## 2007 Sportster Main Wiring Harness Change

As previously communicated in Service Bulletin M-1203 there has been a change to the 2007 XL main wire harness. The parts manuals do not correctly list both early and late part numbers.

Figure 1. Main Wiring Harness Caddy Assembly: Early Style (top) and Late Style (bottom)

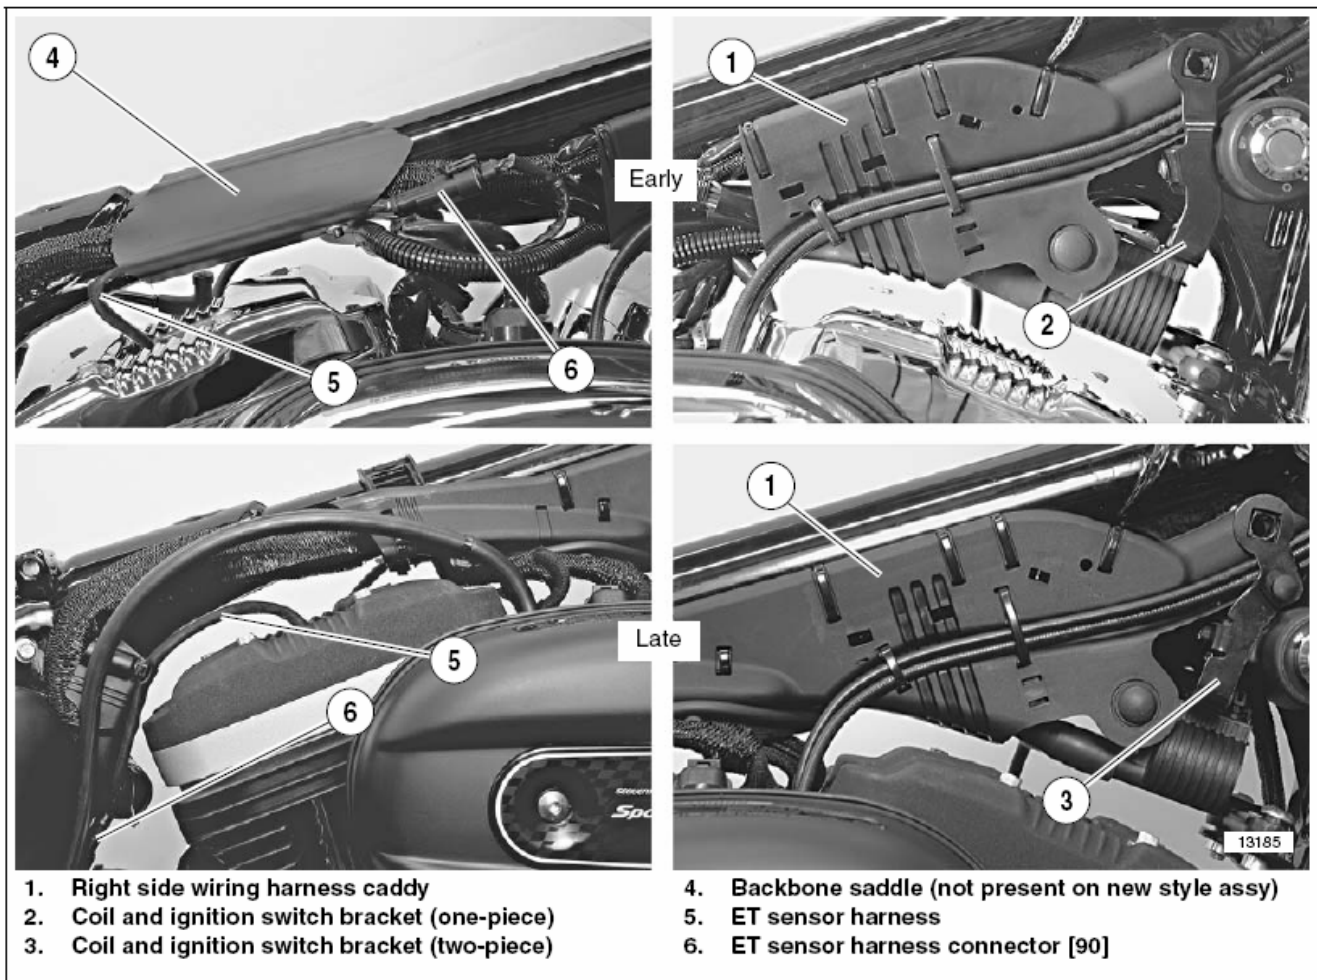
The **Early** part number is **70224-07** and was used in production thru **1/30/2007**.

The **Late** part number is **70181-07** which has been used in production since **1/31/2007**.

Make sure to correctly identify and order the correct harness for your application as they are not interchangeable.

The pictures below from Service bulletin M-1203 show the differences between Early and Late harnesses.
